SUBJECT: Forwards answers to NRC 910321 station blackout questions.

Subject: 10 CFR §50.63, *Loss Of All Alternating Current Power*  
R. E. Ginna Nuclear Power Plant  
Docket Number 50-244

**RG&E Answers To The NRC's March 21, 1991 Station Blackout Questions**  
**Page 1 of 4**

Design Analysis  
Ginna Station  
Sizing of Vital Batteries

FIGURE B1

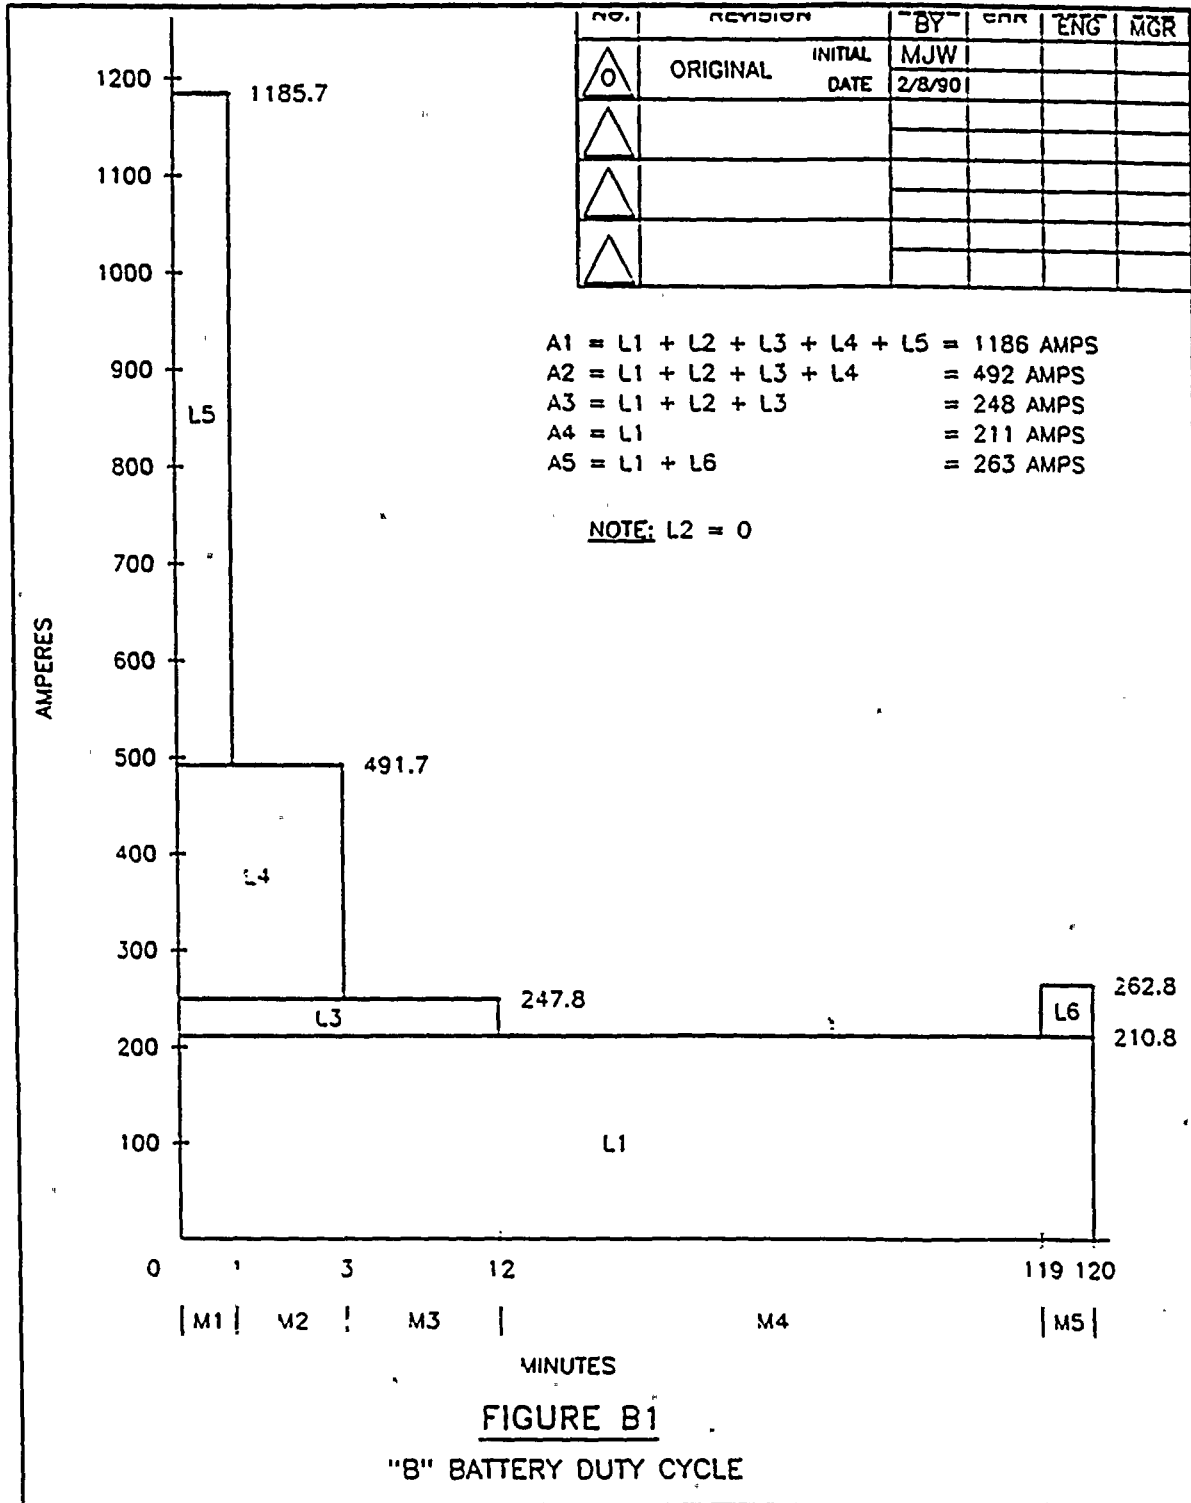
Provide the battery loads and the battery capacity calculation which was performed to verify that the installed Class 1E batteries have sufficient capacity to provide power for all connected loads during a four hour SBO event.

**Response:** The requested information and analyses are included in Attachment 1. As noted on the cover memo, several of the larger DC loads on the station batteries are being removed during the refueling outage that is now underway. Therefore, the attached analyses are conservative.
